Access Compliance Report

Public Rights-of-Way

(Curb Ramps)

| Intersection ID: 43374 | Main Street: COOPER'S RIDGE LN | Cross Street: BERNBROOKE_SHADOW LN | Location: E |

| ADA ID: 16D6F284C99C | Ramp Type: PerpDiag | Initial Pass/Fail: Fail | Overall Compliance: No |

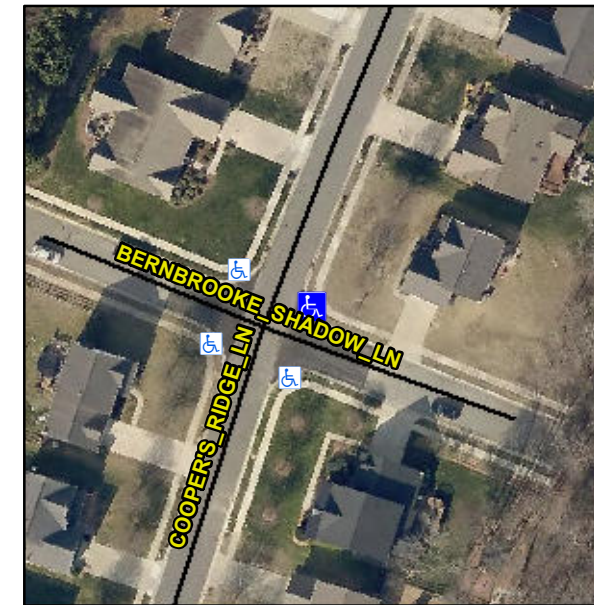
Not Found, R304.5.1, R304.5.3

| Compliance | Description | Data | Compliance | Description | Data |
|------------|-----------------------|-------|------------|-----------------------------|-------|
| No | Ramp Width (in) | 42.0 | No | Ramp XSlope (%) | 7.7 |

Remove & Replace Curb Ramp With Two New Directional Ramps or Equivalent.
